**Hydraulic Fracturing of Zone 3  
United Nuclear Corporation Church Rock Superfund Site  
Administrative Order (Docket No. CERCLA 6-11-89)**

On behalf United Nuclear Corporation (UNC), MACTEC Engineering and Consulting (MACTEC) has prepared this letter to respond to comments presented by the United State Environmental Protection Agency (USEPA) and the Navajo Nation Environmental Protection Agency (Navajo Nation EPA) on our December 23, 2003 report entitled "Final Report, Hydraulic Fracturing Pilot Test Results and Preliminary Full Scale Design, United Nuclear Church Rock Facility". USEPA comments, which also provided comments from the New Mexico Environment Department (NMED) were provided in a letter dated March 10, 2004. Comments from the Navajo Nation EPA were provided in a letter dated March 11, 2004.

**CONTINGENCY PLAN  
PRELIMINARY FULL SCALE DESIGN  
UNITED NUCLEUR CHURCH ROCK FACILITY**

Figure 1: Recommended Downhole Tiltmeter Observation Well Locations

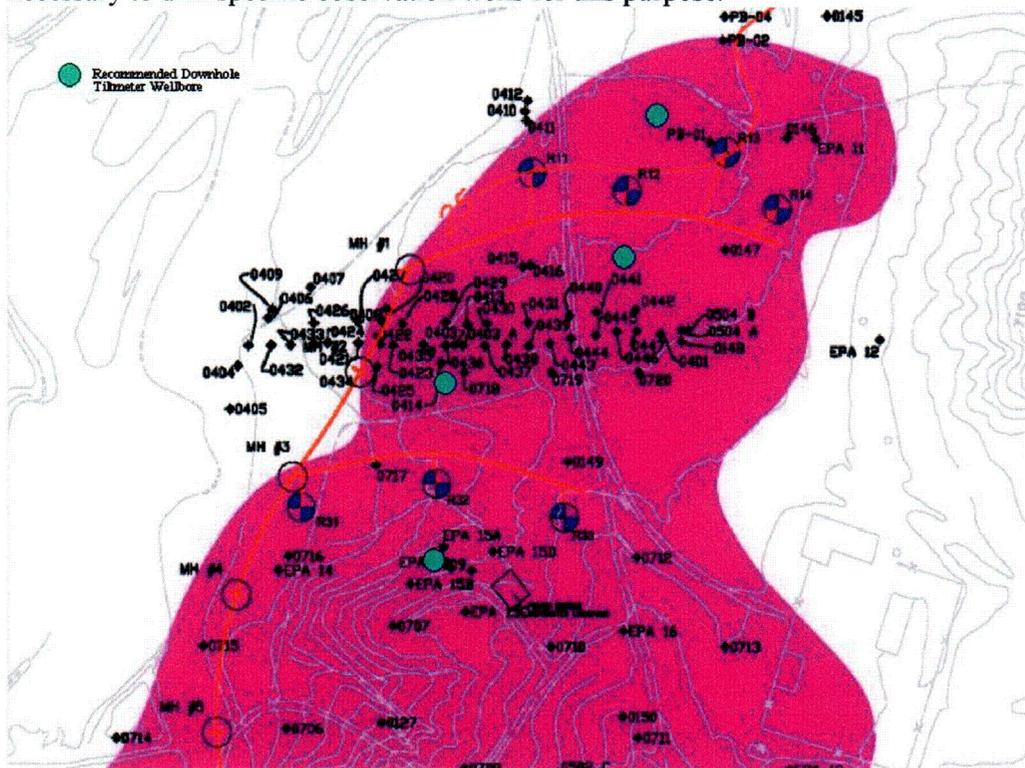
*(6) Fracture diagnostics for the proposed hydraulic fracturing will involve the use of surface tilt meters in a 32-unit array (for each well?). During Stage 2 of the pilot hydraulic fracturing operations, where the induced fracture moved up vertically 50 feet, the tilt meter array used did not detect a vertical component at the time. Will use of surface tilt meters be sufficient to detect any and all undesired vertical prolongations? Downhole tilt meters at depths near the zone to be fractured are useful for determining fracture height.*

As discussed at our meeting, with respect to downhole tilt meters, we agree and plan to use them (see attached contingency plan).

To obtain the best possible hydraulic fracture growth images, the downhole tiltmeter array will essentially straddle the intended fracture interval. A diagram of this is shown in Figure 2. It may be necessary to drill specific observation wells for this purpose.
